ADDENDUM No. 1
Request for Competitive Sealed Proposals (CSP)
19CSP136 Roof Replacement at Fulmore Middle School

Date: June 27, 2019
To: All Plan Holders
RE: Roof Improvements to Fulmore Middle School
 AISD Project No. 19-0036-FULMR
 EE Project No. 004-012

ADDENDUM NO. 1

R2.00

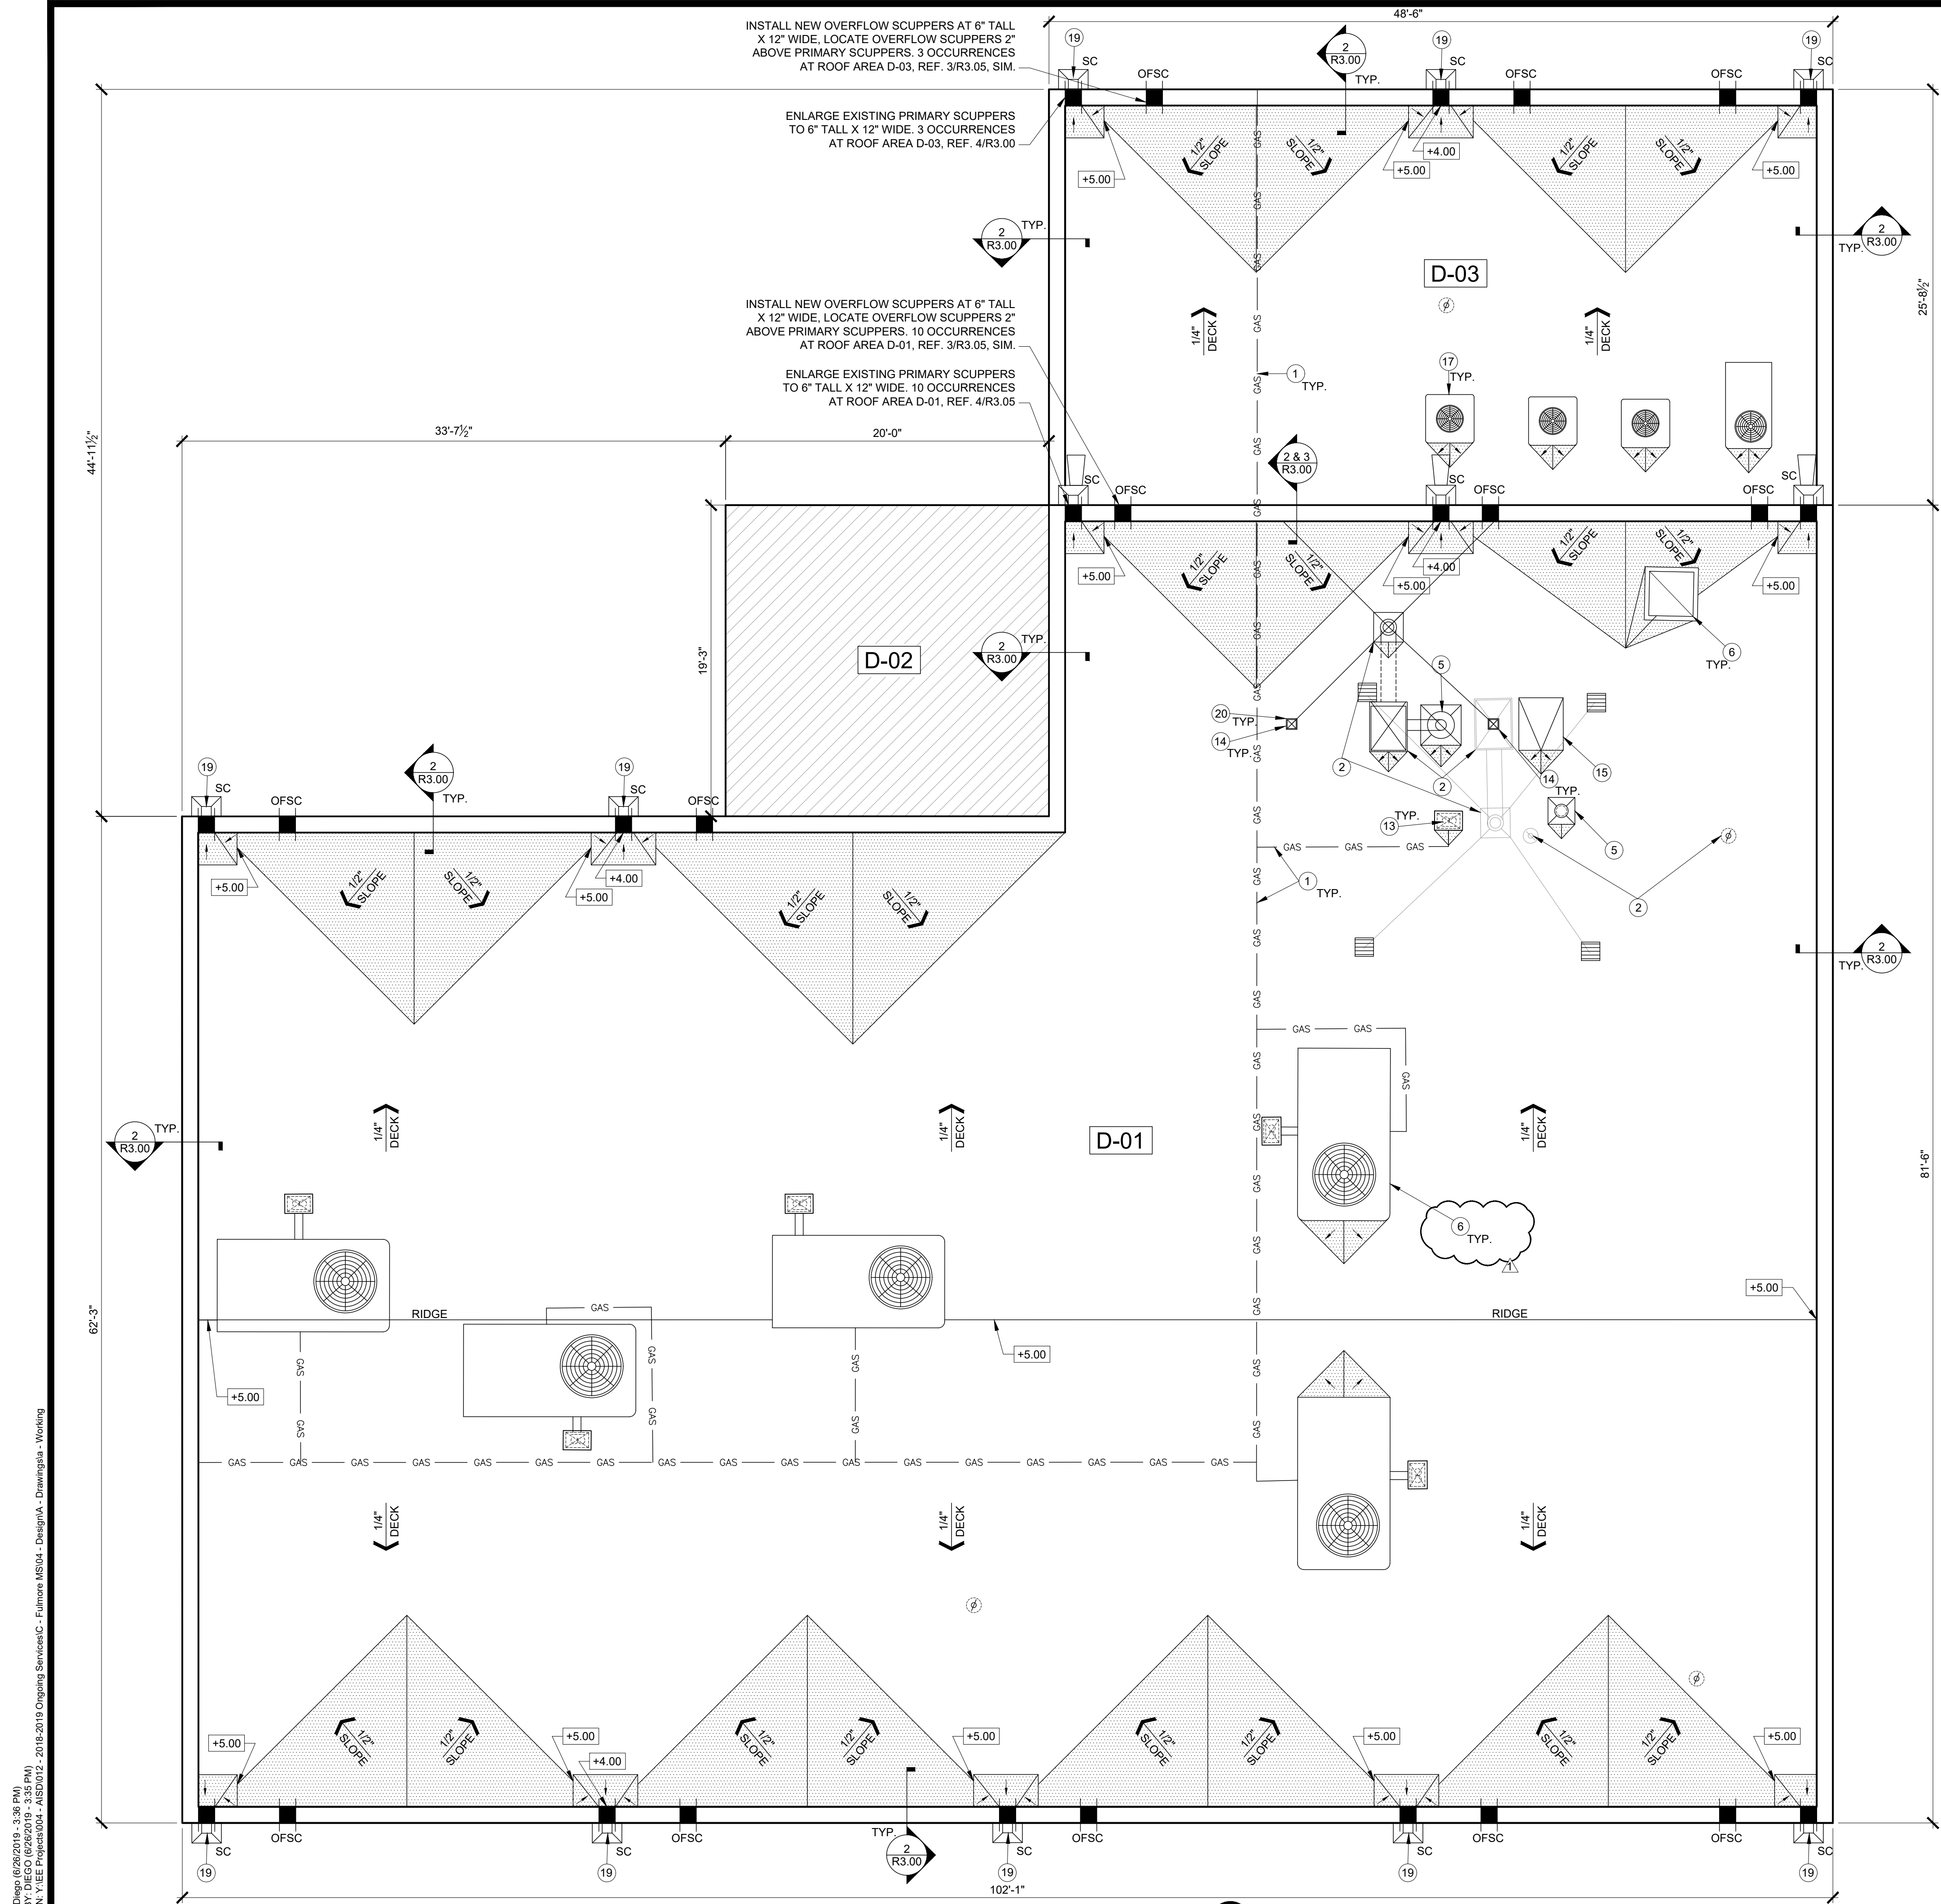
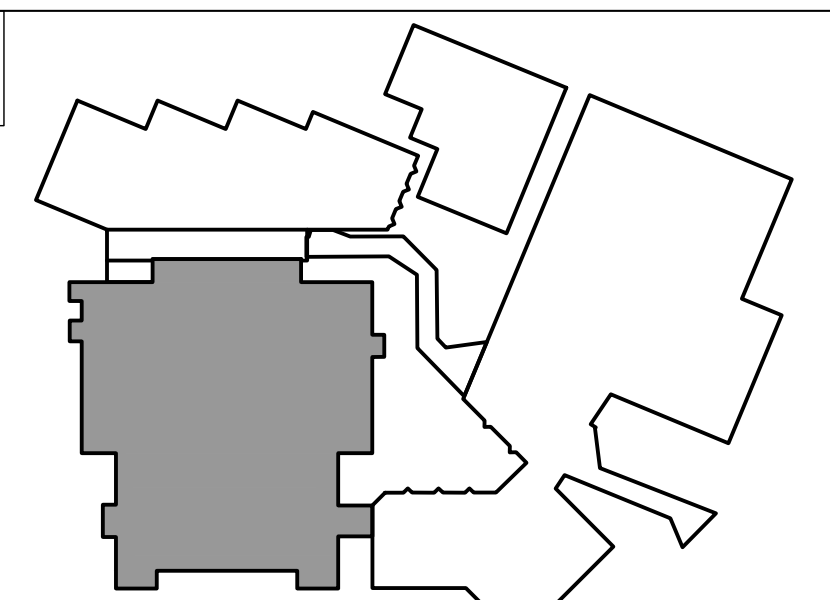
Sheet	Revision
R2.00	Replace with attached revised R2.00, clarifying key notes to reference mechanical drawings and including portable platform requirements for MEP equipment on Roof Area A-10.
R2.01	Replace with attached revised R2.01, clarifying key notes to reference mechanical drawings and including requirement on roof plan to raise mechanical units on Roof Area D-01 to match MEP drawings.
R2.02	Replace with attached revised R2.01, clarifying extents of walk pads.
